E8363B-01B**S E R V I C E****N O T E**Supersedes:
E8363B-01A**E8363B PNA Series RF Network Analyzers**

Serial Numbers: 00000000 thru 46999999

Many of the Front Panel Interface (FPI) boards which were installed per Service Note E8363B-01A need to be modified or replaced because the RPG shaft can disconnect, and the front panel keyboard and RPG can respond intermittently upon boot up.

Figure 1

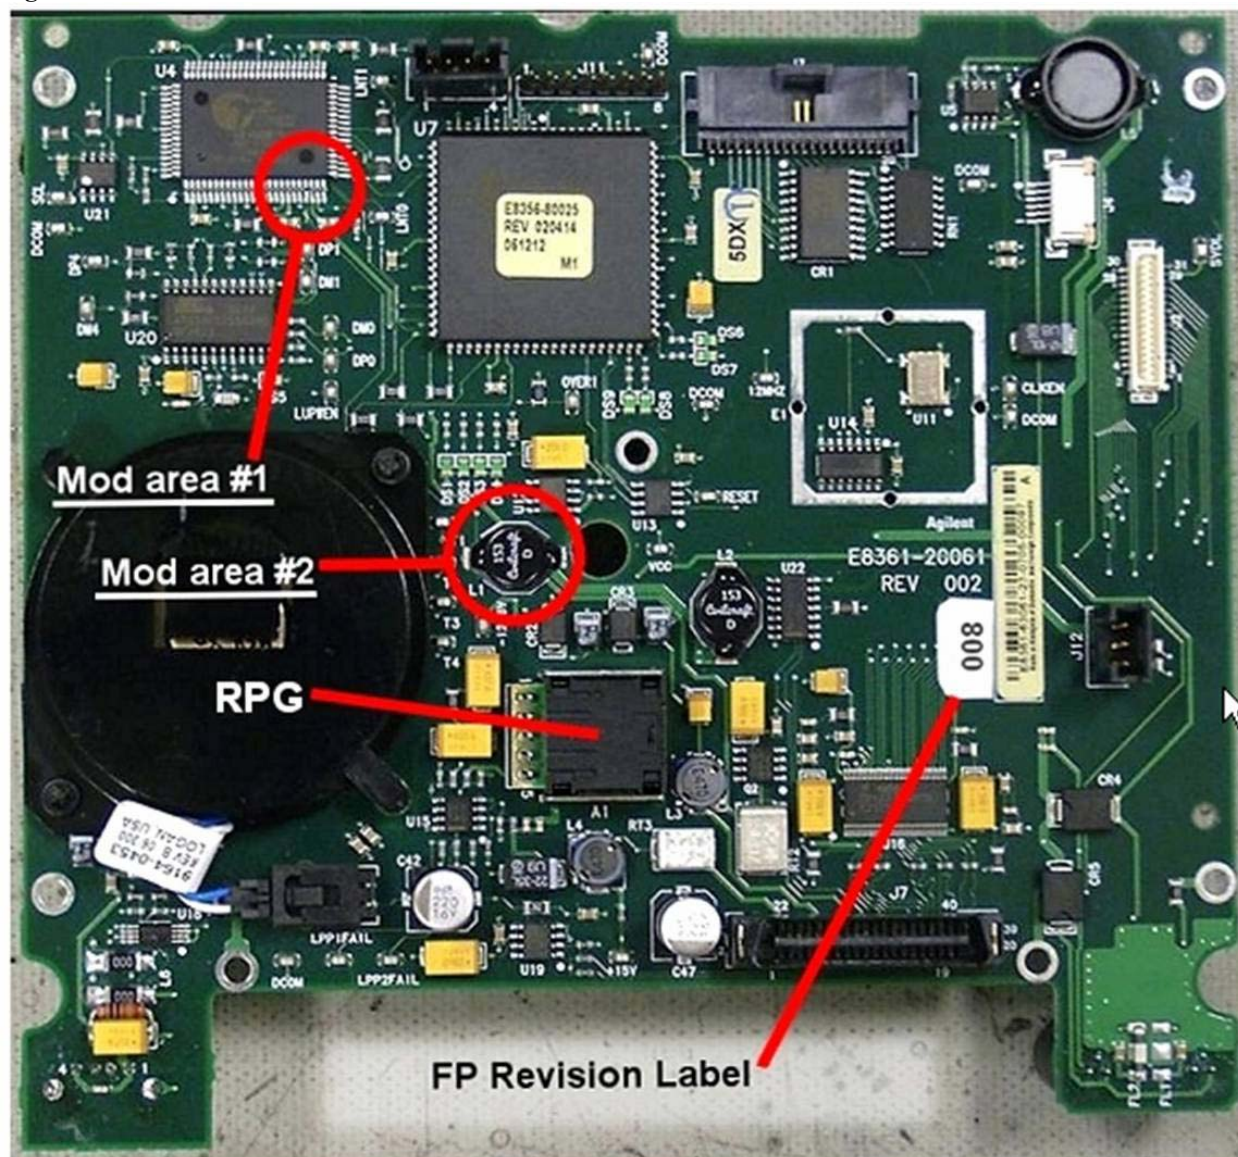
Refer to Figure 1 for the two modification areas to be addressed. Note that while this picture happens to show the FPI board completely removed from the front frame assembly, this is not necessary to perform the required modifications.

- Modification #1 consists of shorting two pins of U4 together with a small amount of solder.
- Modification #2 consist of removing L1.

Unsolder and completely remove the black surface mount inductor L1 from the front panel assembly board. This is no longer needed and can be discarded.

Figure 2

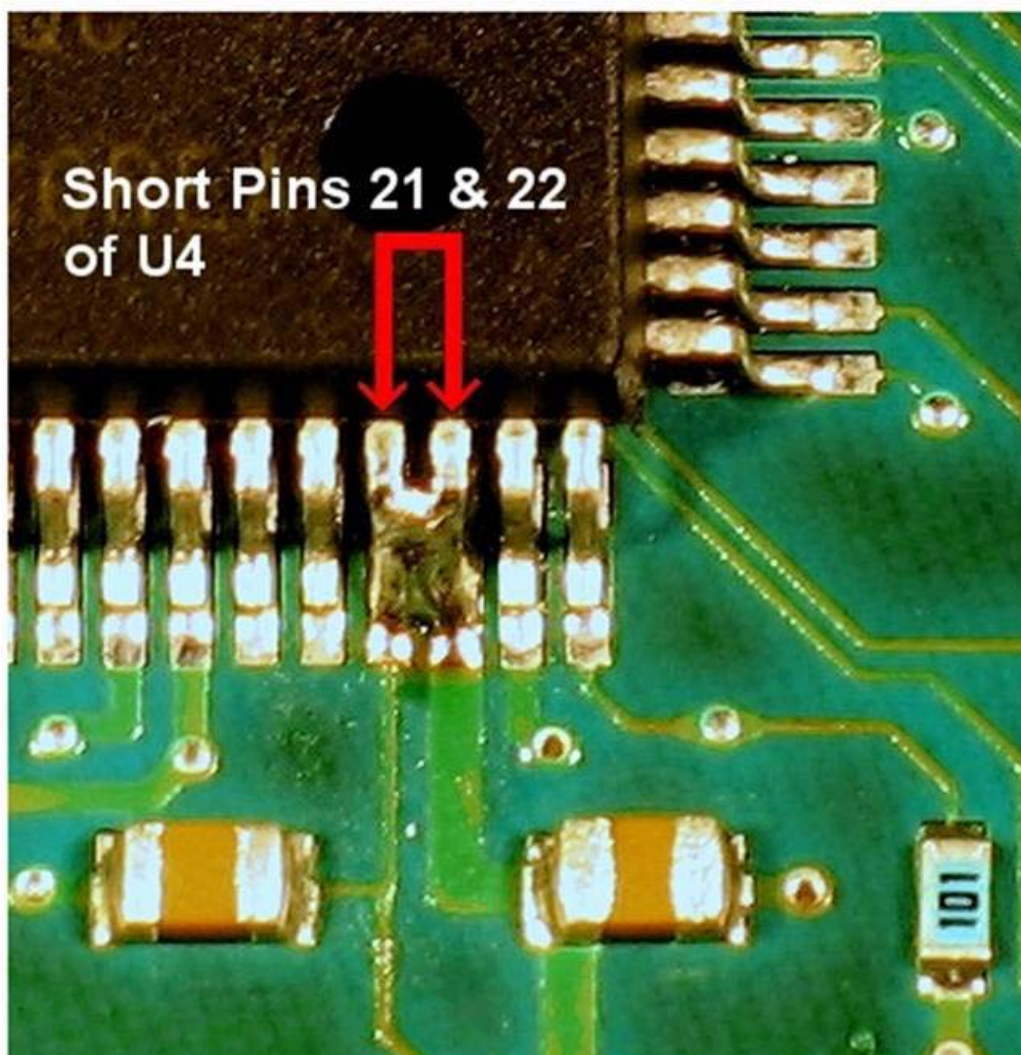
Carefully solder pins 21 and 22 together on U4. Refer to Figure 2 for the exact location. Use care so that no other pins are shorted. Use of a very fine tip soldering iron is recommended and a large work-task magnifying glass is very helpful.
